# Service Bulletin

Bulletin No.: 24-NA-277  
Date: March, 2025

**Subject: Rear Seat False Latch Concerns**

6791542

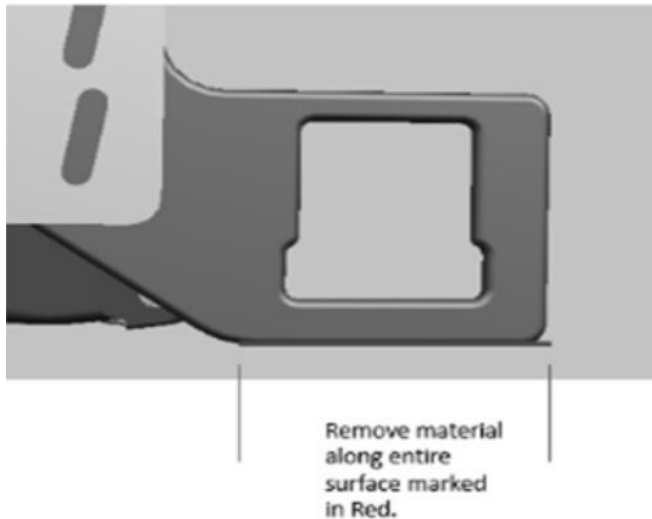
1. Verify Seat Latch Condition – A false latch condition exists when the red latch indication flag drops without full latch function of seatback latch to striker. When in a false latch condition, seatback latch can disengage from striker without functioning the seat latch release handle.

- 1.1. Measure the striker with calipers or micrometer at three points (as seen in image above).
- 1.2. If striker is larger than 10.7mm, rework to body procedure (Begin Step 2).
- 1.3. If the striker is not larger than 10.7mm, Replace Seat, Contact TAC, and Submit FPR.
